Office Action Summary

10/060,945

CARRICK ET AL.

DETAILED ACTION

FIG. 4A

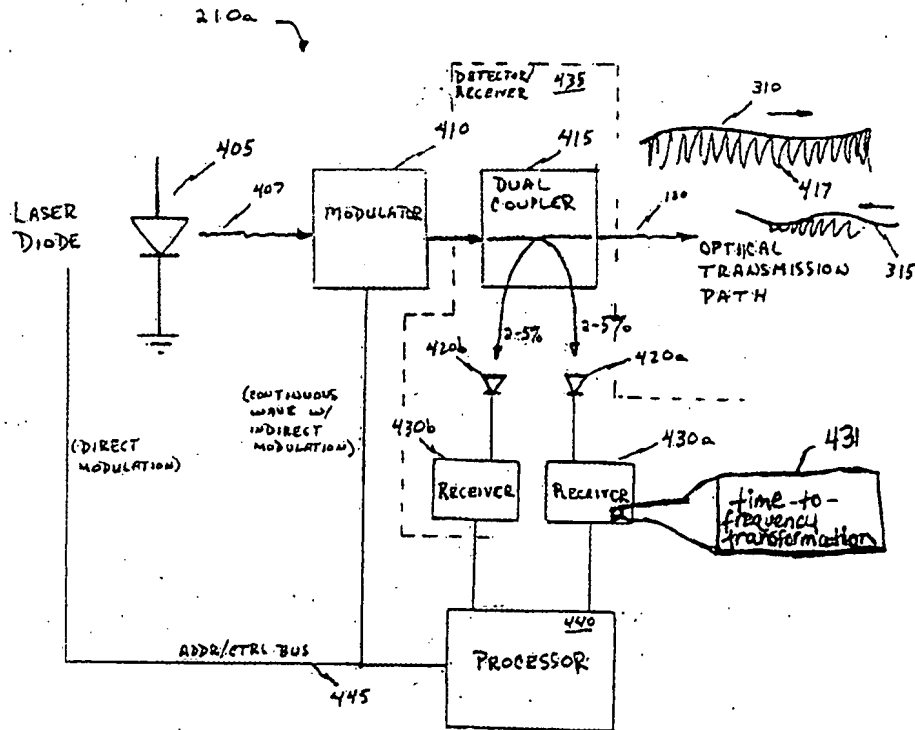
In Fig. 4A, component 431 was absent in previous versions of the drawings. Moreover, the original disclosure does not support component 431. Accordingly, component 431 constitutes new matter. That is, the disclosure teaches the use of time-to-frequency transformation by narrow band digital filters (p. 22, l. 12-15). Such digital filters are in the processor 440 (p. 22, l. 4). As a remedy, Examiner respectfully suggests the movement of component 431 from receiver 430a to processor 440.

Disapproved by Dsk
04 August 2007

FIG. 4D

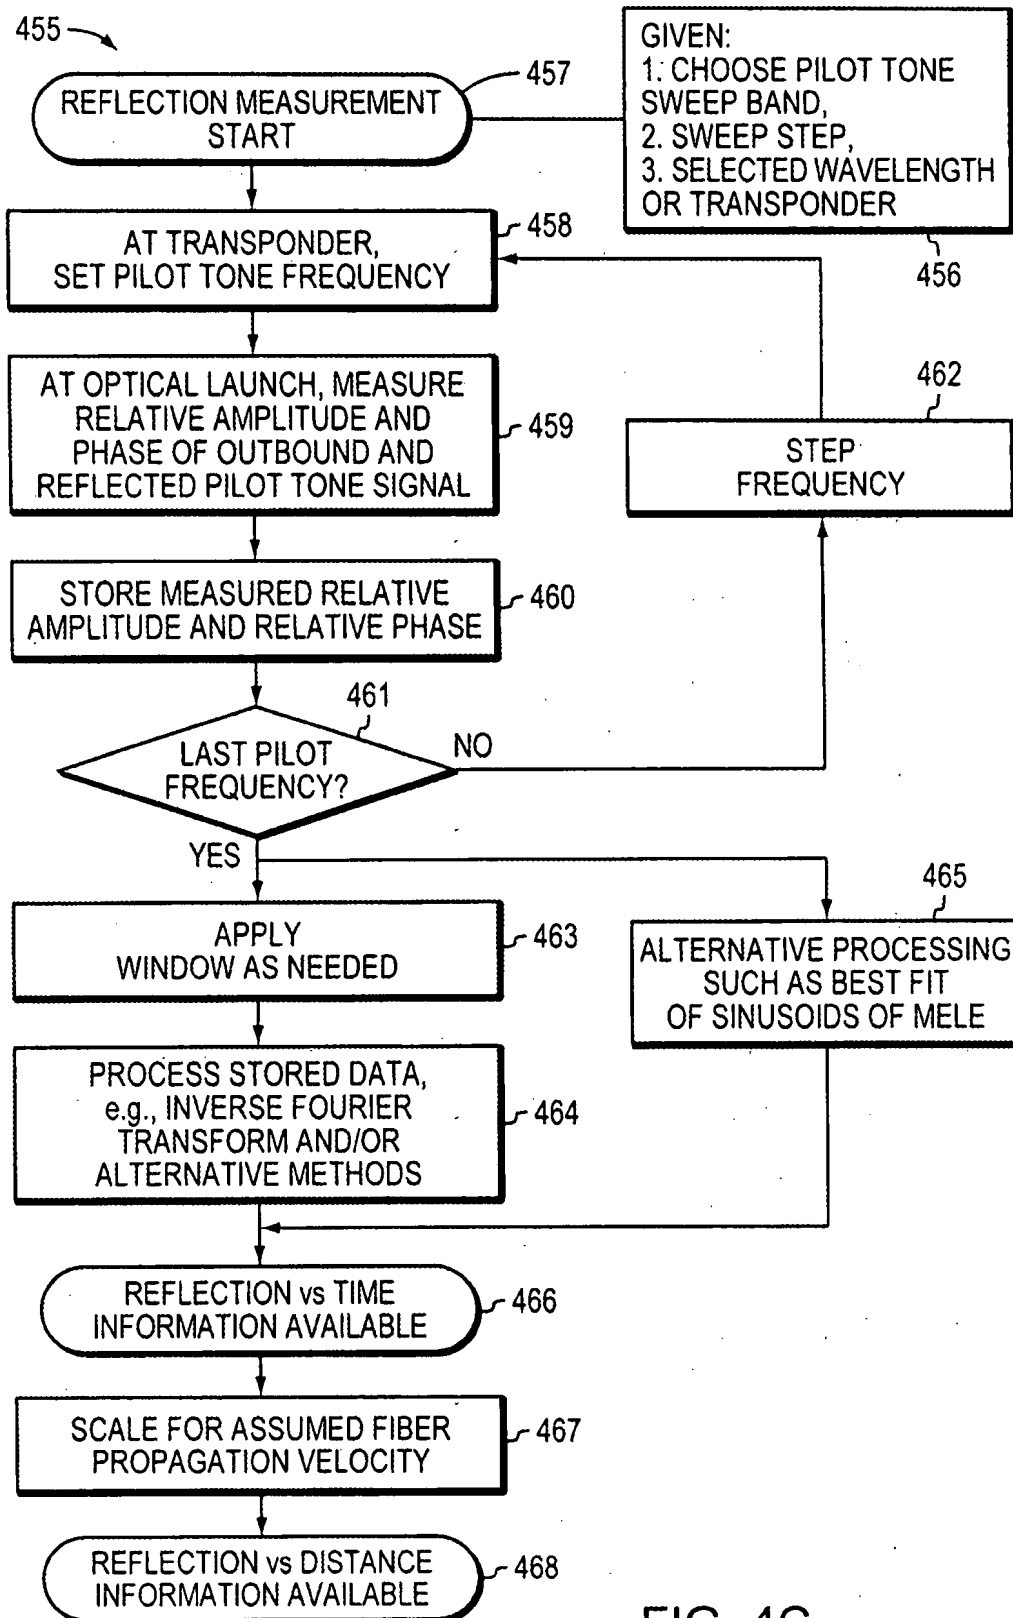
In Fig. 4D, step 475 may be intended to be "MORE WAVELENGTHS" instead of "MORE WAVELENGTH". See original drawing Fig. 4D filed on 30 January 2002.

FIG. 7

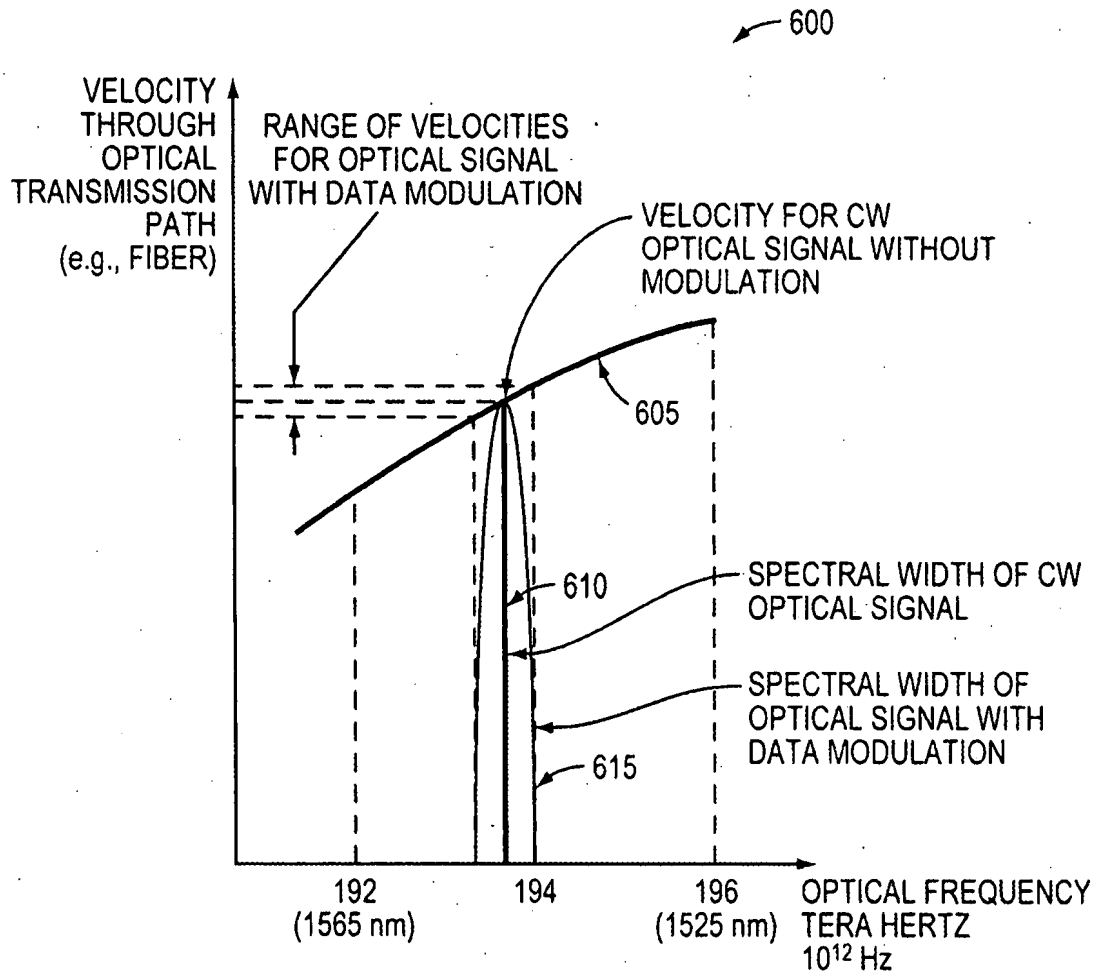
In Fig. 7, the diagrams are missing the logic level indicator "1" for the vertical axis. See original drawing Fig. 7 filed on 30 January 2002.
